Design Brief - REVISED

6310 Hazeldean Rd. Development

June 2024

Review of UDRP's comments received on October 6th, 2022

CONCEPT SITE PLAN - PROPOSED IN FALL 2022

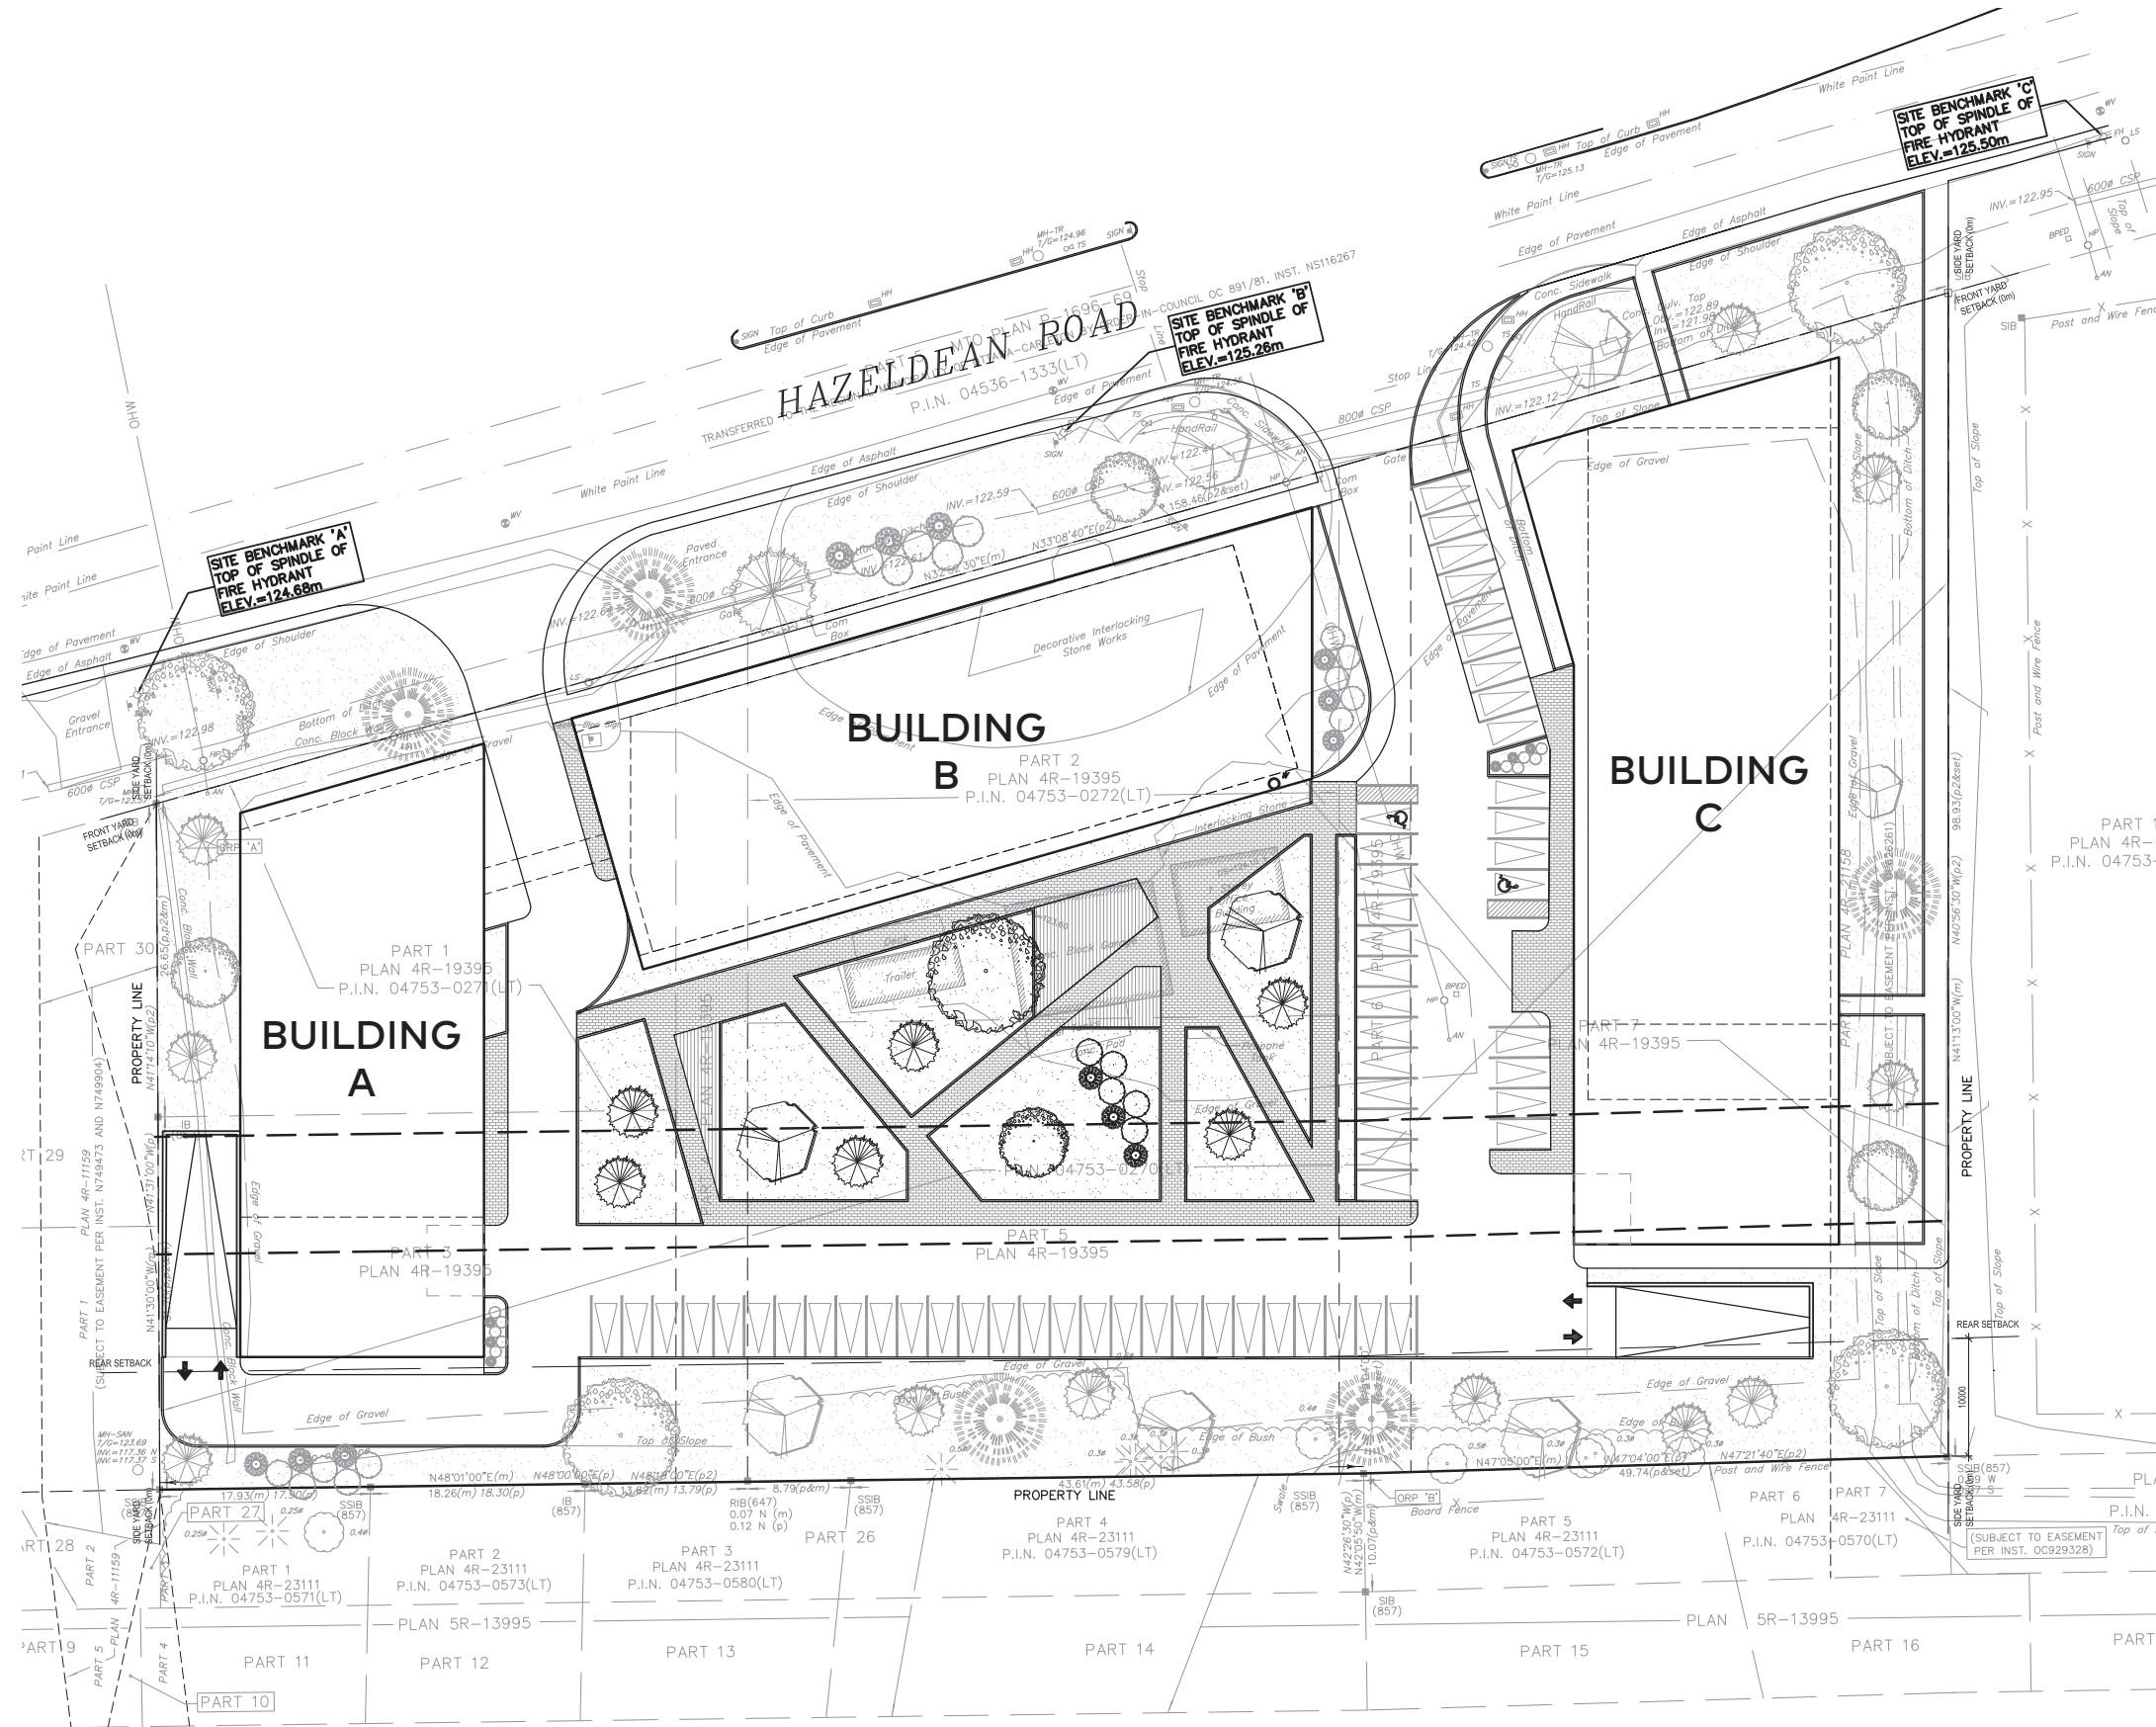
The Panel believes that the site will set a precedent in the area where a strong architectural expression and public realm vision is needed to embed the site into the greater landscape and neighbourhood context.

The Panel supports, in principle, more density on the site; however, there are more opportunities to enhance the public realm and landscaping and to build a sense of community while considering how the proposal will set a standard for the future.

At this stage of the development process, the Panel expects to see a proposal where the architecture has been resolved, is viable, will be built and become part of the neighbourhood. A more detailed proposal would enable the Panel to provide more wholesome comments and input.

The Panel expressed disappointment with the current level of resolution of the architecture.

The Panel recommends the City not grant the changes to the setbacks as the site provides enough space to accommodate the buildings while maintaining the setbacks requirements.

The Panel recommends increasing the density on Hazeldean Road and reorienting Building B to parallel the street to create an urbanized corridor. Should the building be parallel to the street, the Panel recommends connecting Buildings A and B with glazed volume. Additionally, the proponent should consider elongating the building to eliminate the north-south wing since the inside corner units of an L-shaped building have with limited access to light.

The proponent should consider relocating the drop-off area underground on the north side of Building C to provide access to all three buildings. This would open up the layby space and allow for more greenery and reconfiguration of the parking layout.

The Panel questioned the appropriateness and amount of commercial space on the ground floor, given retail may not be viable. The space could be used for residential amenities.

The Panel believes the site's configuration is dominated by parking. The proponent should develop a strong pedestrian realm proposal that accommodates bicycle parking and has a high-quality landscape with outdoor amenities and a residential character.

The Panel has concerns with the scale and massing on the site as the buildings do not reflect the neighbourhood's character and only relate to each other. The Panel recommends the proponent study the area and its architecture to establish a language that complements the neighbourhood.

The Panel notes the ground floors configurations are repeated throughout the site, and the suite plans might do not reflect the siting or architecture of the individual buildings. The proponent should consider providing a high-quality amenity at grade, as the amount of space allocated for each suite is questionable.

The proponent should consider more variety on the facades and larger glazed openings and the introduction of large family units to break up the sameness of the buildings. The proponent should also consider adding more glazing with masonry at key corners to provide amination at the ground floor level.

The Panel believes Building C should have more articulation to break up the long façade.

The proponent should consider stepping and terracing the building toward the neighbourhood to provide a more significant transition and greenery at the rear

The Panel has concerns with the parking at the rear, given the possibility of headlights spilling into neighbours' yards. The parking does not allow for an outdoor amenity area due to the limited open space. The proponent should consider eliminating parking at the rear or designing the open spaces first, before laying out the parking.

There is an opportunity to add a bosque of trees and have a wrap-around landscape adjacent to the townhouses to create a strong landscape design and to strengthen the existing buffer.

The proponent should focus on site sustainability by implementing stormwater management and providing opportunities within the landscape to integrate utilities.

Acknowledged, a new updated concept has been prepared that includes a strong contemporary architectural expression. This new proposal includes a stronger ground plane experience with ground floor accessible units and strong active entrances for the two buildings proposed.

Agree, the new concept provides a stronger presence to Hazeldean while providing a strong transition to the neighbouring properties to the south. Though a future ROW is considered in the site plan placement of the buildings, we anticipated that this new street scape will eventually include for stronger pedestrian sidewalks, a bike path and significant green space that is included in this proposal.

Acknowledged, the team has included Figurr Architects who have prepared a more detailed exploration of the development, including enhanced urban design experiences, building massings and aesthetics, as well as how the buildings reflect the existing urban conditions along Hazeldean Rd. and the neighbouring properties.

Acknowledged, responded to in previous comment

Acknowledged, the site planning in the new proposal respects all required setbacks.

Acknowledged, a new proposal by Figurr Architects new proposes a two building solution with a strong street face along Hazeldean. Massings and heights have been carefully developed to contribute to a strong main street façade, an appropriate transition to neighboring properties, as well as considering sun and shading of the massing against this and other neighboring sites.

Acknowledged, a new two building proposal has been prepared with a stronger centralized drop off for both buildings under building 1. Parking has now been concentrated within a two storey parkade structure (and u/g garage) that has been clad with light coloured panels and vegetated screens.

Acknowledged, commercial no longer part of new updated proposal.

Acknowledged, at grade parking has been greatly minimized to provide mostly for visitors. A new 2 storey parkade (and u/g garage) will house remaining parking. A large amenity terrace will be located above the garage parkade.

Acknowledged, this new proposal has a stronger contemporary language. This area of the city does NOT have a specific and strong existing building language. The area is dominated by a mix match of suburban single family homes, industrial lands and typical suburban commercial strip centres. We do not believe that these are great examples to draw from and believe that the new concept – through thoughtful massing, proper transitions, and enhanced green buffer areas - provides a strong refined aesthetic that actually responds to enhancing urban planes.

Acknowledged, the new proposal has been properly explored to include proper ground floor programming for these types of buildings. Programs have been located to enhance the public realm with clean open and active entrances and amenity areas along Hazeldean. Bike rooms, move-in rooms and access to other supportive programs have been properly located to further support the concept.

Acknowledged, the concept attempts to address these concerns with a strong contemporary design as also previously mentioned in past comments. Larger units will be part of the project but a final unit typology will be part of a future Site Plan Control submission.

Acknowledged, please see new proposed concept that has a two building solution with varying setbacks and material explorations.

Acknowledged, new concept has been primarily developed by exploring that major aspect along the neighbouring properties.

Acknowledged, a new enclosed parking structure integrated with the buildings has been proposed. This greatly reduces the at grade parking. Project will ensure a minimum fence line and significant 10m green buffer zone between the rear lot lines and any building or parking area.

Acknowledged, please see new concept that greatly increases the use of green landscaping and significant buffer zones.

Acknowledged, as the concept now evolves, this will be part of the proposed project.
